EDWIN I. HATCH NUCLEAR PLANT
UNIT 1 AND UNIT 2

IMPROVED TECHNICAL SPECIFICATIONS

Revision C

EDWIN I. HATCH NUCLEAR PLANT
IMPROVED TECHNICAL SPECIFICATIONS
REVISION INSERTION INSTRUCTIONS
REVISION C

4.9.A.2. Standby AC Power Supply (Diesel Generators 1A, 1B, and 1C)
(Continued)

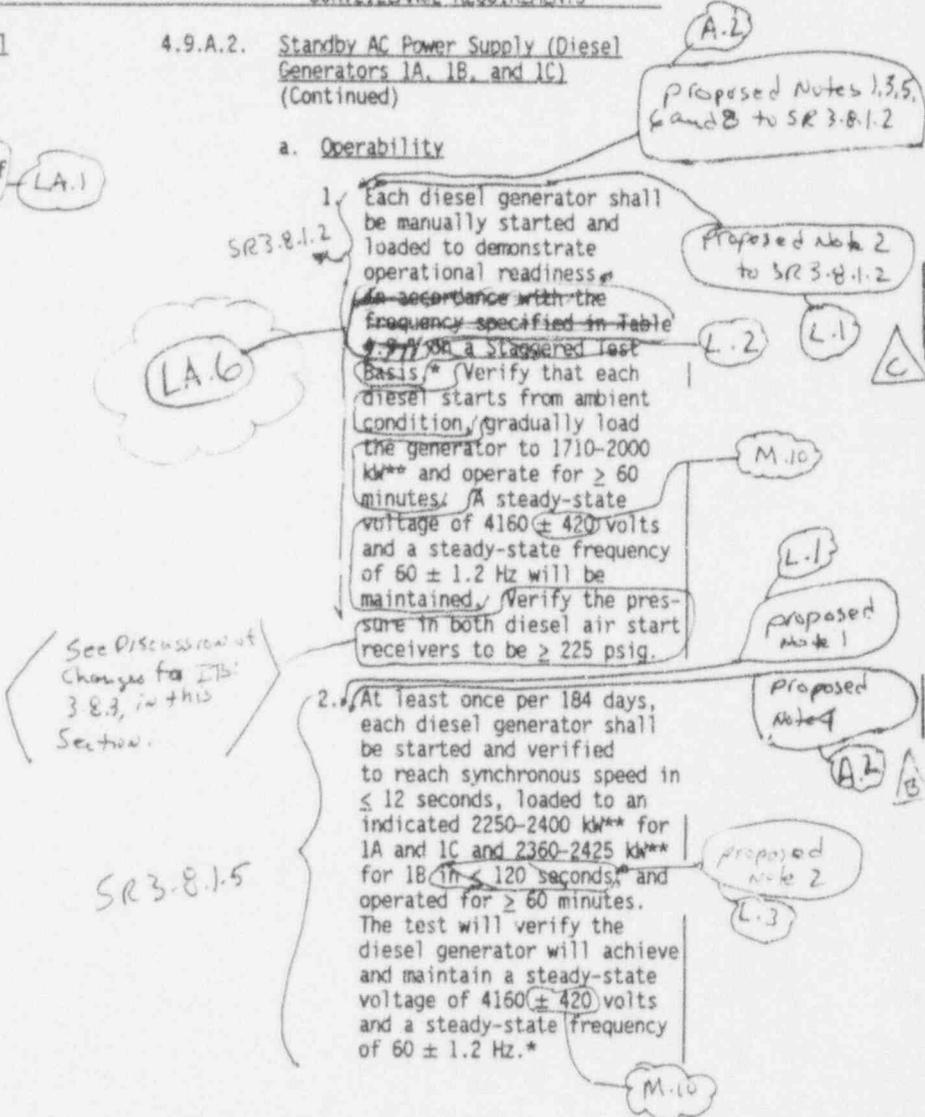
a. Operability
The diesel generator itself and its auxiliaries are operable. (LA.1)

1. Each diesel generator shall be manually started and loaded to demonstrate operational readiness in accordance with the frequency specified in Table 3.8.1.2 on a staggered test basis.* Verify that each diesel starts from ambient condition, gradually load the generator to 1710-2000 kW** and operate for ≥ 60 minutes. A steady-state voltage of 4160 ± 420 volts and a steady-state frequency of 60 ± 1.2 Hz will be maintained. Verify the pressure in both diesel air start receivers to be ≥ 225 psig.

2. At least once per 184 days, each diesel generator shall be started and verified to reach synchronous speed in ≤ 12 seconds, loaded to an indicated 2250-2400 kW** for 1A and 1C and 2360-2425 kW** for 1B in ≤ 120 seconds,* and operated for ≥ 60 minutes. The test will verify the diesel generator will achieve and maintain a steady-state voltage of 4160 ± 420 volts and a steady-state frequency of 60 ± 1.2 Hz.*
